SUBJECT: CHANGES TO TECHNICAL SPECIFICATIONS REGARDING RPV PRESSURE AND TEMPERATURE LIMITS

RE: GRAND GULF NUCLEAR STATION, UNIT 1

MISSISSIPPI POWER & LIGHT COMPANY
SYSTEM ENERGY RESOURCES, INC.
SOUTH MISSISSIPPI ELECTRIC POWER ASSOCIATION
DOCKET NO. 50-416
GRAND GULF NUCLEAR STATION, UNIT 1
AMENDMENT TO FACILITY OPERATING LICENSE

Amendment No. 32
License No. NPF-29

Figure 3.4.6.1-1

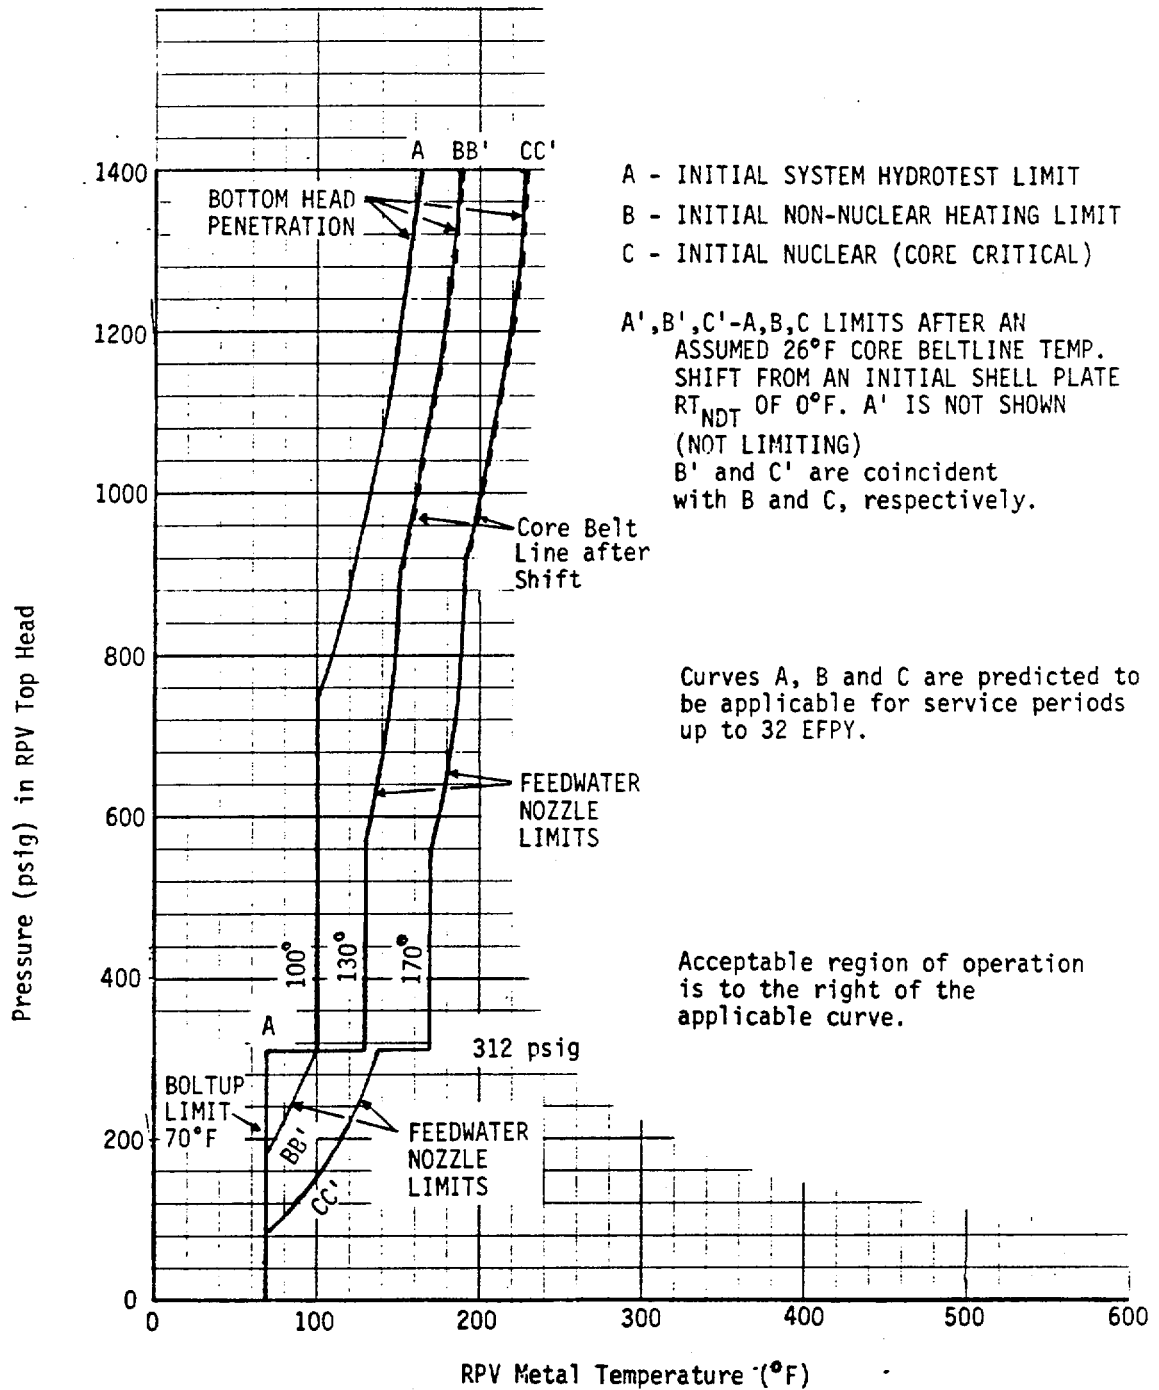
The present RPV pressure and temperature limits in the Technical Specifications (Figure 3.4.6.1-1 "Minimum Reactor Pressure Vessel Metal Temperature vs. Reactor Vessel Pressure") were included in the full power operating license for GGNS-1 issued November 1, 1984. During a recent review of changes to the Final Safety Analysis Report (FSAR), the licensee found that the RPV limit curves in the updated FSAR (which are identical to TS Figure 3.4.6.1-1) did not correspond to the correct RPV limit curves provided by the NSSS vendor, the General Electric Company (GE). The limit curves affected are the curves below 312 psig for non-nuclear heating (Curve B) and nuclear heating with the core critical (Curve C). The system hydrotest limit (Curve A) is not affected by the error.

The present erroneous curves are non-conservative with respect to the correct GE supplied curves. The licensee stated that a GE analysis has concluded that while operation with the present curves does not significantly impact plant safety, the limit curves in the TSs should be corrected.

In addition to the changes to Curves B and C on TS Figure 3.4.6.1-1, the reference to NEDO-21778-A in Figure 3.4.6.1-1 and in Bases 3/4.4.6 would be deleted because Appendix G to 10 CFR 50 supersedes NEDO-21778-A as a basis for Curve C. Another change to the Bases is to delete the statement "as well as adjustments for possible errors in the pressure and temperature sensing instruments" because errors in RPV pressure and temperature measurements were not included in the calculation of limit curves A', B', and C'. The staff agrees with the deletion of NEDO-21778-A and reference to measurement errors for the reasons stated above.

The basis for this conclusion is that for a normal heatup and pressurization, the GGNS-1 operating procedures result in plant conditions which avoid the restricted area on the proposed correct curves. A review of plant records by the licensee confirmed that the plant has not operated in the proposed new restricted areas of the limit curves. Furthermore, the licensee has stated that operating procedures for GGNS-1 were changed to use the GE supplied curves until TSs are changed to incorporate them. The staff has reviewed the submittals for this amendment and concludes that the GE supplied limit curves are the correct curves and therefore, the proposed changes to the TSs are acceptable.
